STATE OF MAINE
DEPARTMENT OF TRANSPORTATION
16 STATE HOUSE STATION
AUGUSTA, MAINE 04333-0016

October 18, 2024
Subject: Ferry Terminal Rehabilitation
Location: Casco Bay
State WIN: 024685.01
Amendment No. 2

FERRY TERMINALS AT CHEBEAGUE,
CLIFF, GREAT DIAMOND AND PEAKS
ISLANDS

S5

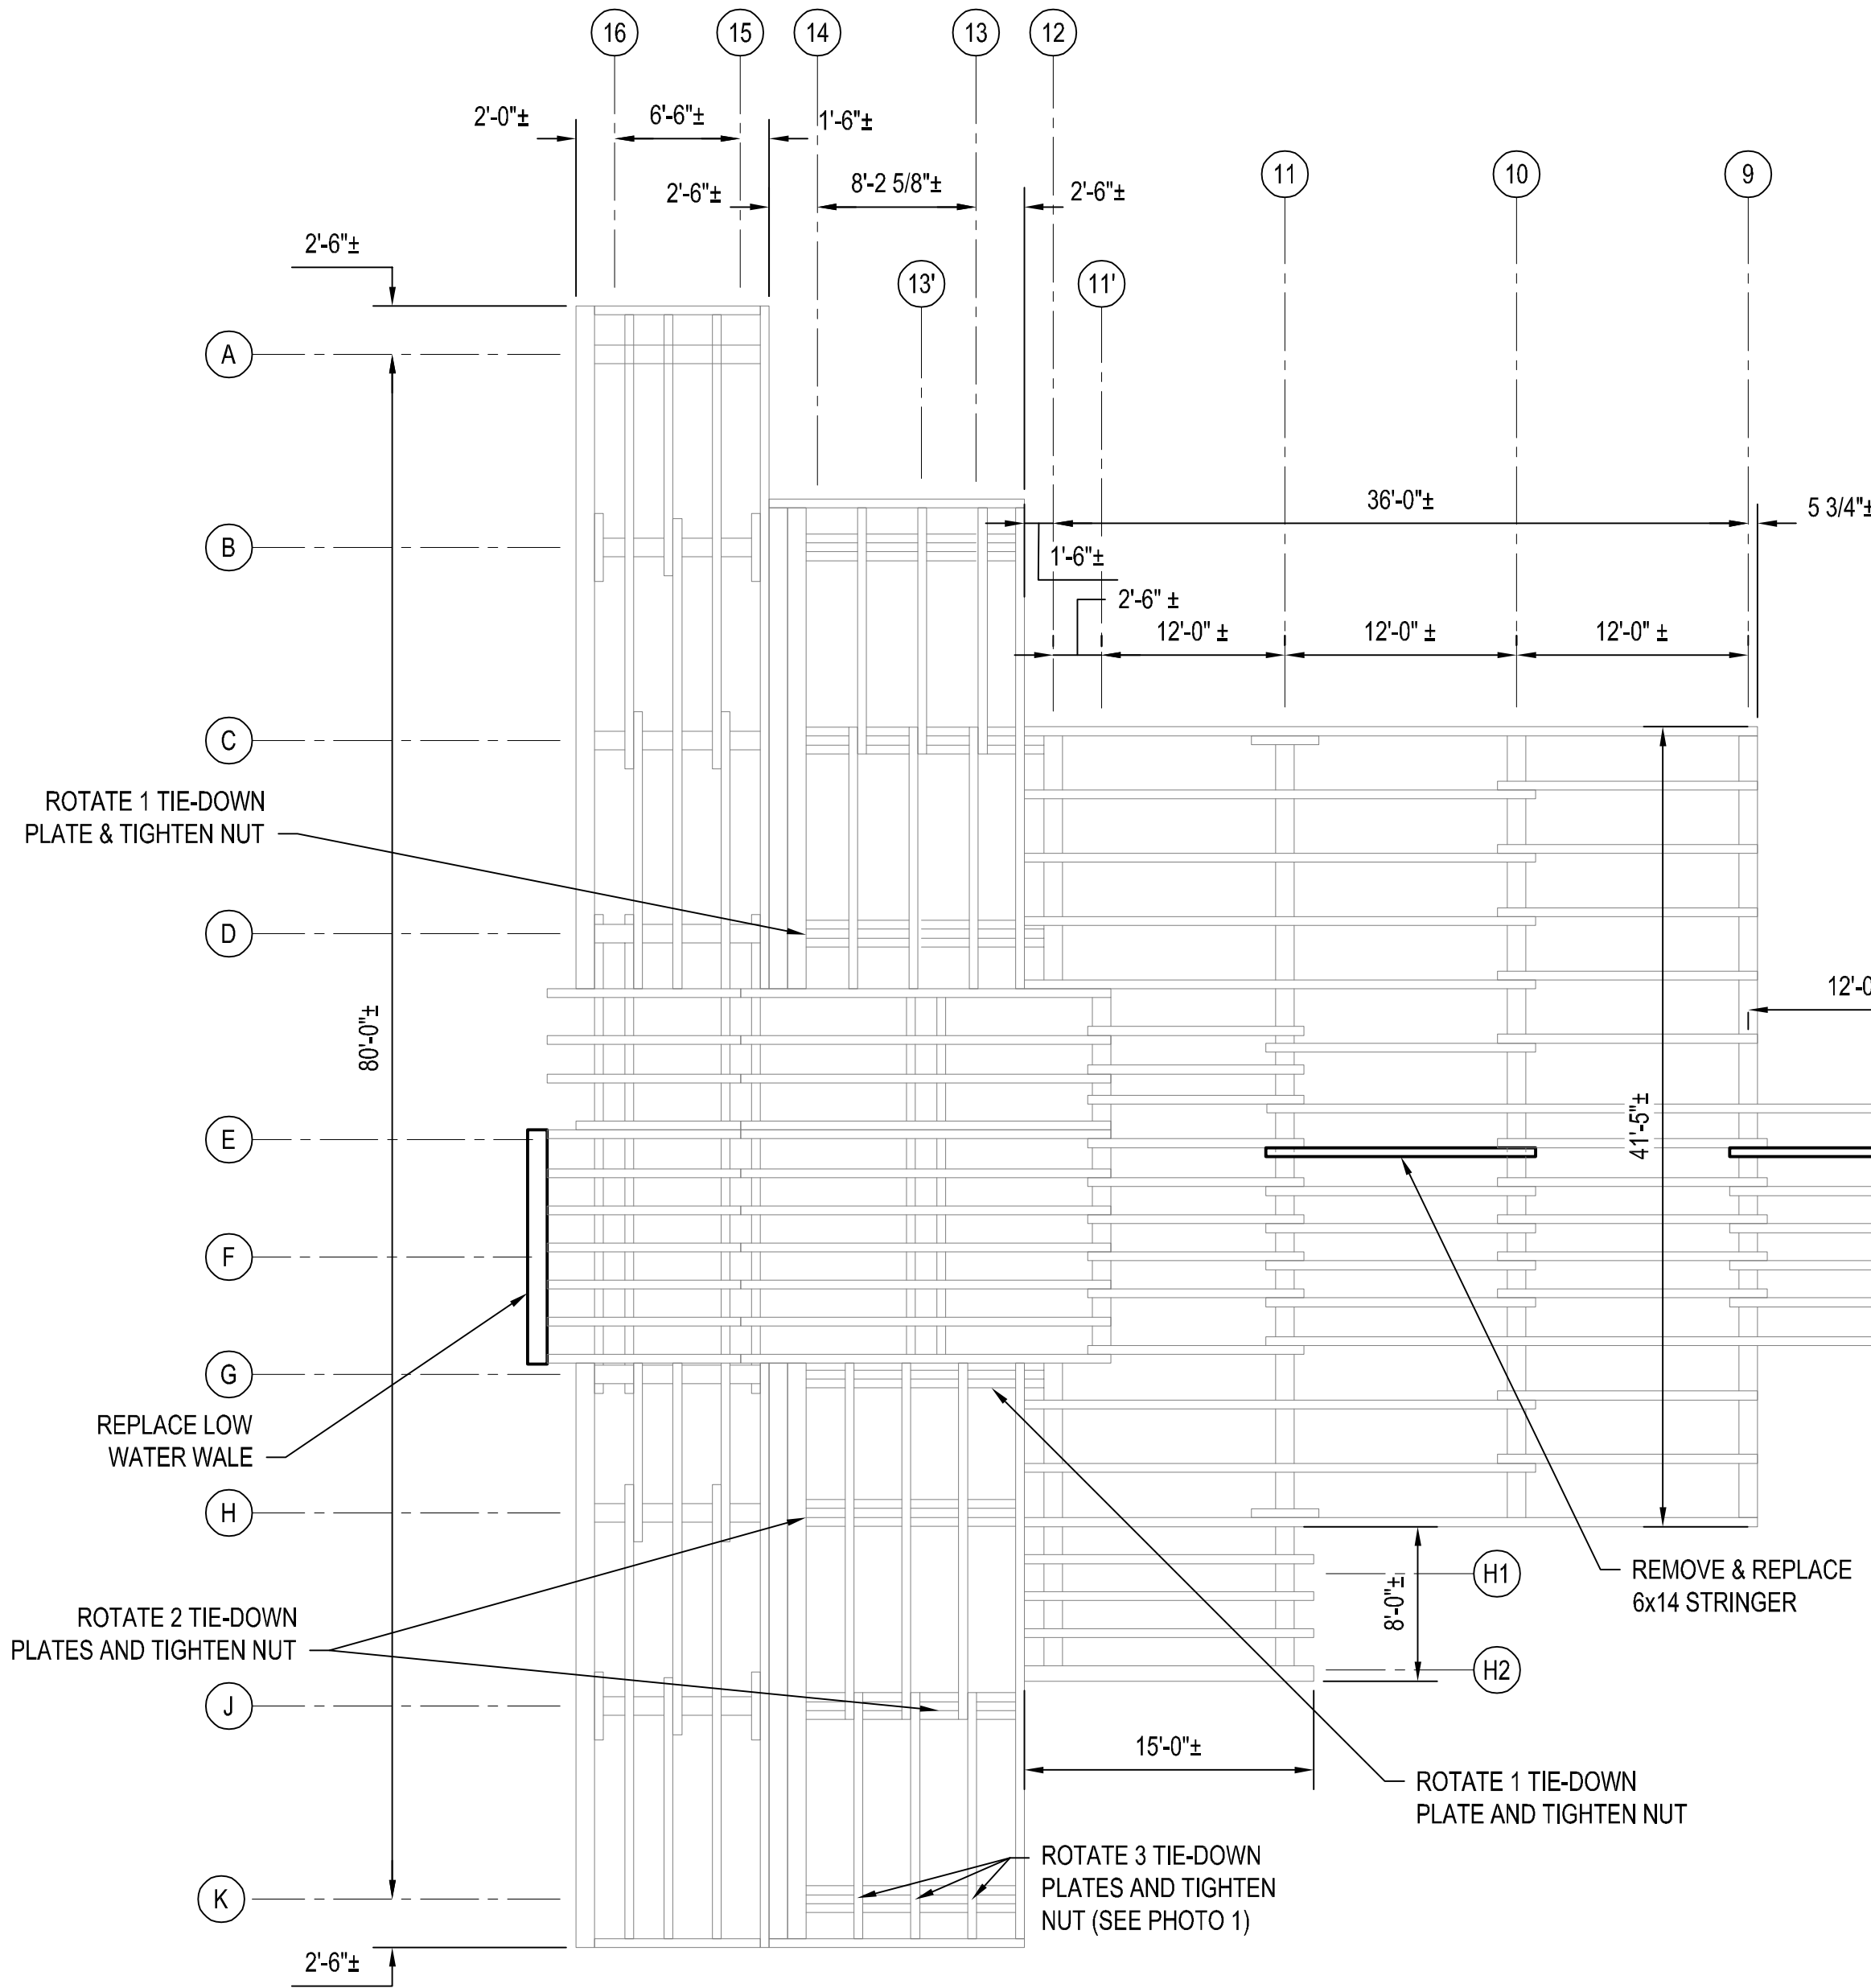
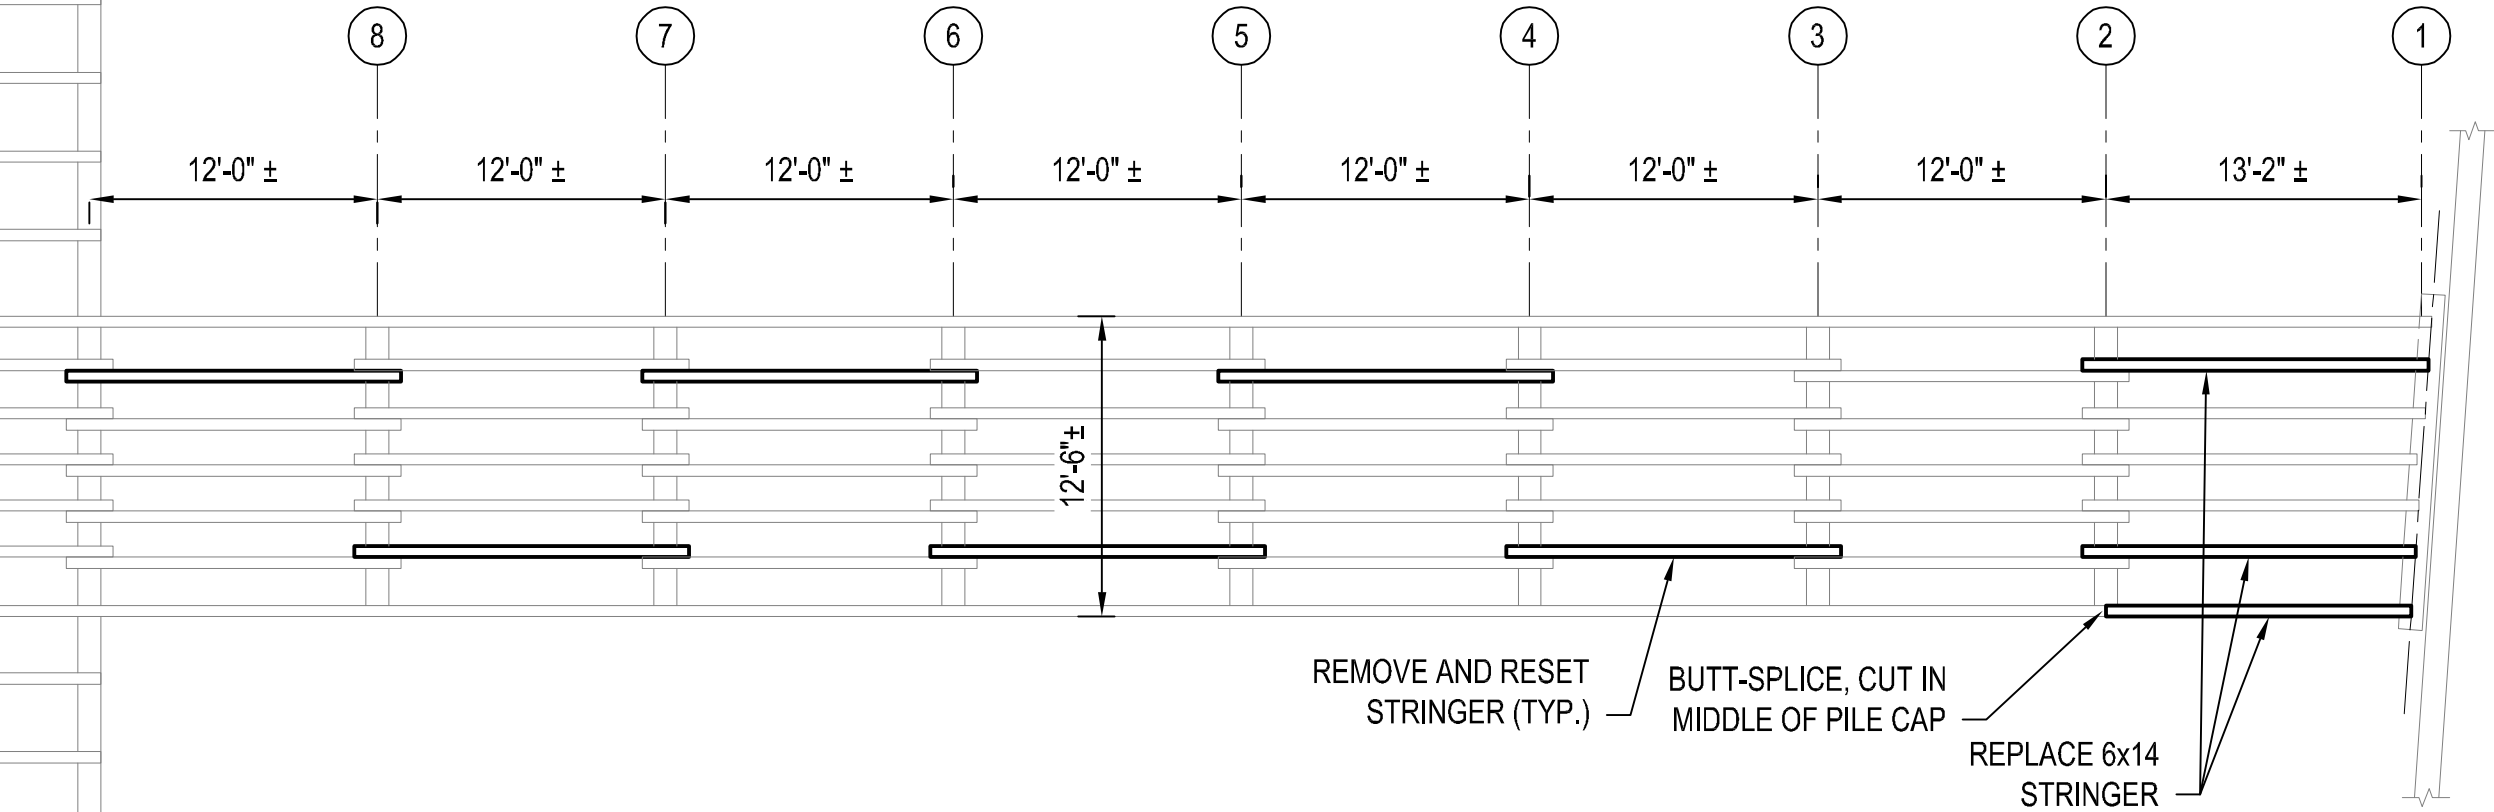
Question: On Sheet S5, note 3 states that the contractor is to "Allow for replacement of up to 12 additional (6x14) stringers as directed by the resident. Work shall be paid under item 528.49 Structural

Timber-Great Diamond Island”. However, Section 528.01 on the provided Special Provision Specification defines structural framing of wood members with thicknesses of 5” (nominal) or more to be classified as “Heavy Timber Construction”. Are the additional (12) stringers for the resident to be priced/billed separately from the 6x14 stringers required for construction? Or will all of these stringers be priced/billed either under item 528.10 or item 528.49?

Response: Per note 3 on S5, the additional stringers as directed by the Resident shall be paid for under Item 528.49 Structural Timber – Great Diamond Island per the board foot. The stringers to be replaced as indicated on Sheet S5 shall be paid for under Item 528.10 Heavy Timber Construction – Great Diamond Island as a Lump Sum. See Special Provision 528 – Structural Timber that has been replaced in its entirety.

SHEET NUMBER
S8
14 OF 19

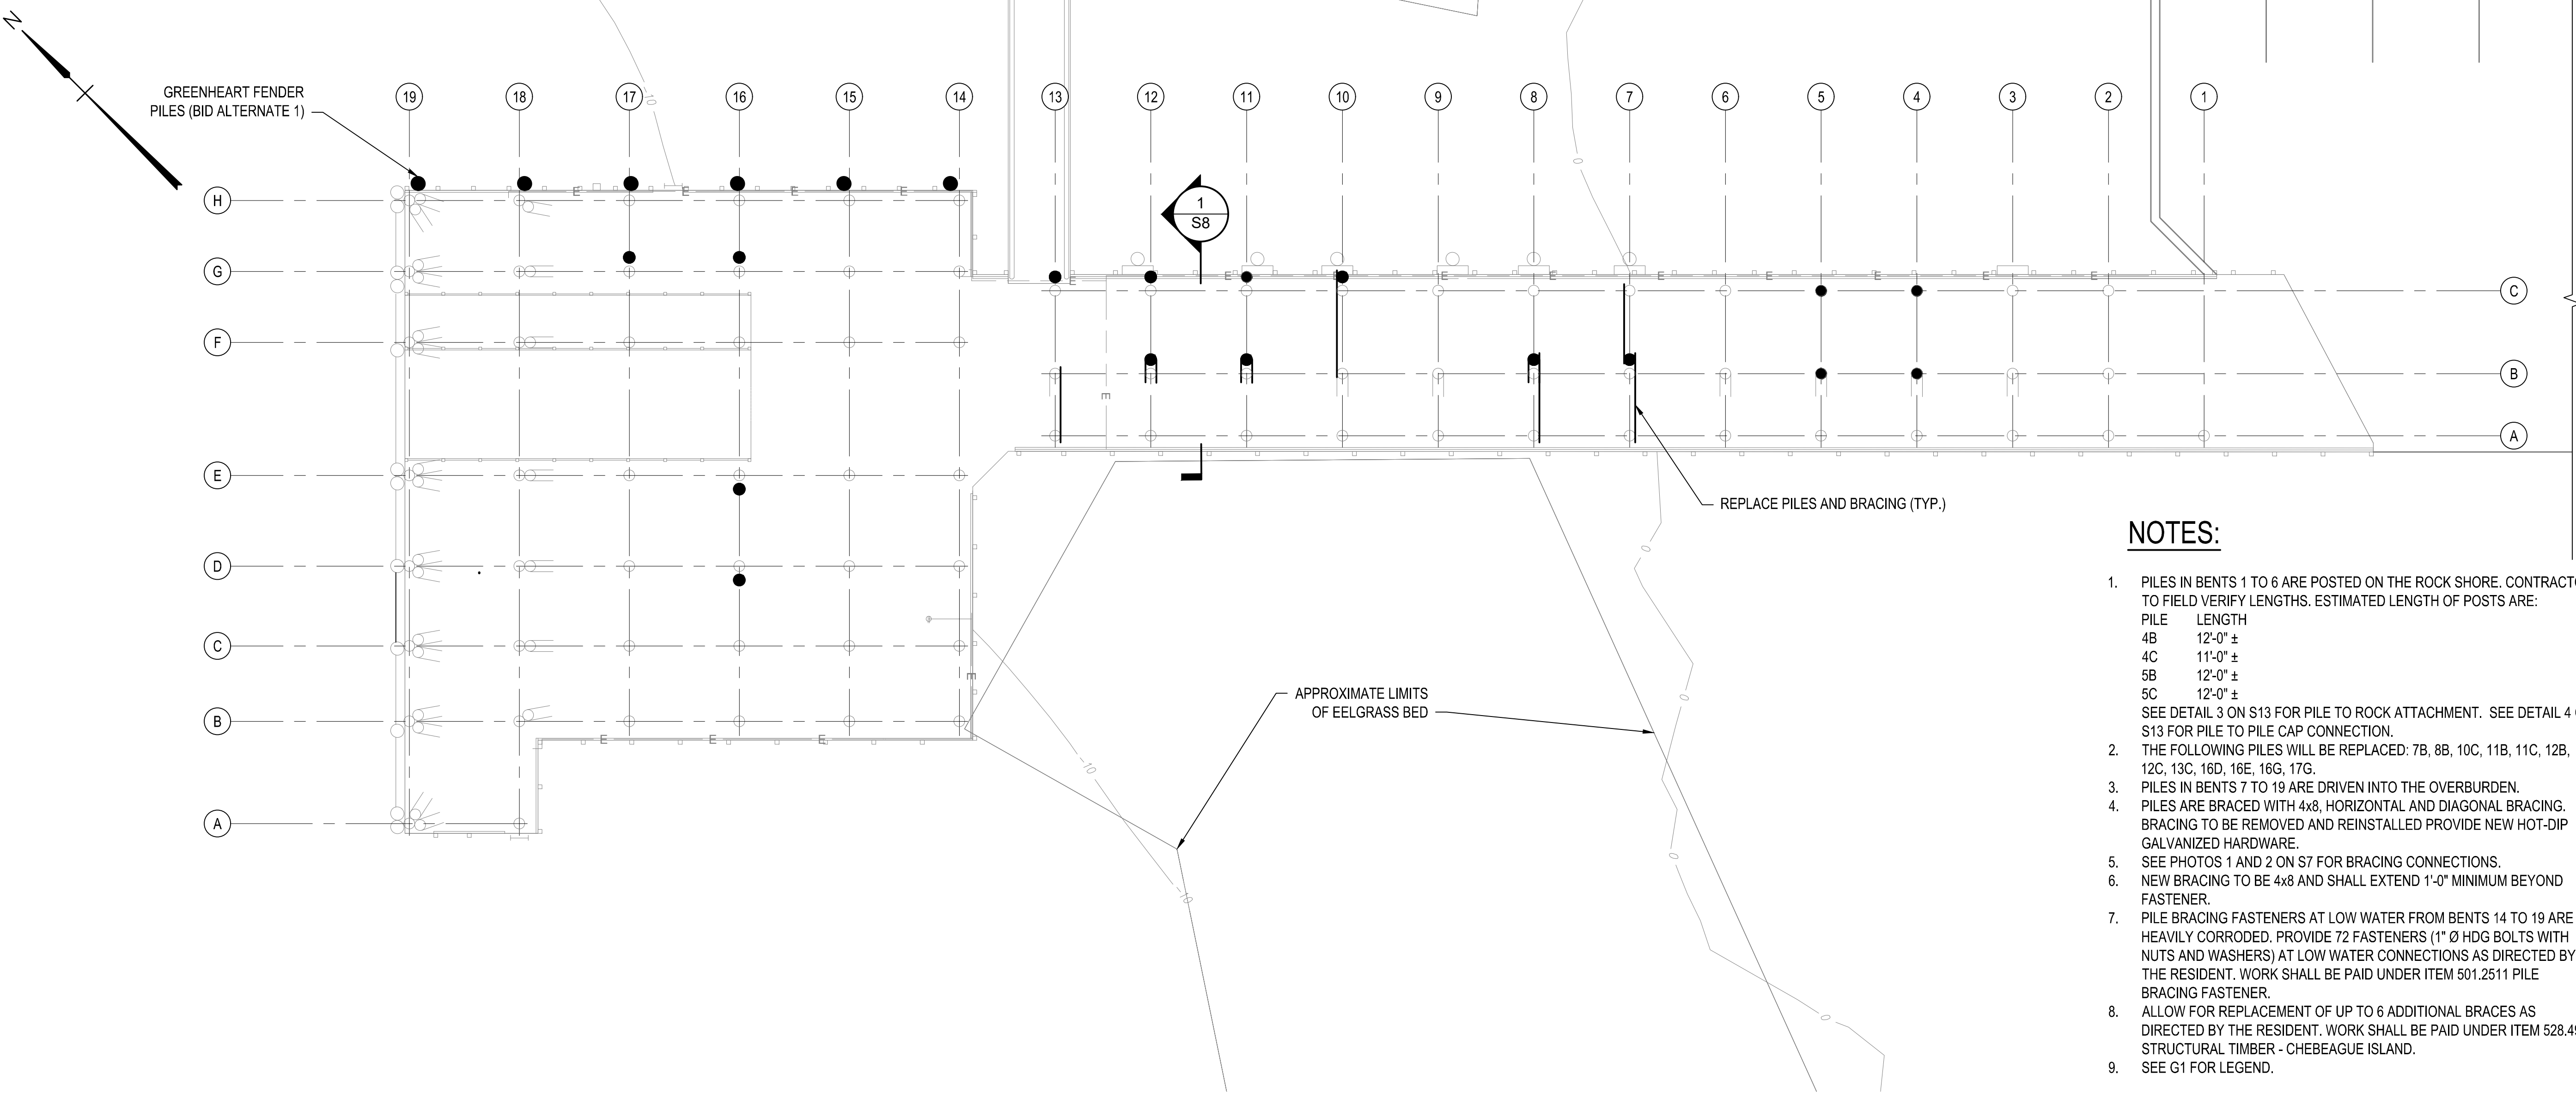
Question: Note 7 on Sheet S8 calls for replacing 72 fasteners that will be paid under item “528.XX Pile Bracing Fastener” Believe the note should read 501.2511

Response: See Note 7 on Sheet S8, “Pile bracing fasteners at low water from bents 14 to 19 are heavily corroded. Provide 72 fasteners (1” Ø HDG bolts with nuts and washers) at low water connections as directed by the resident. Work shall be paid under Item 501.2511 Pile Bracing Fastener.
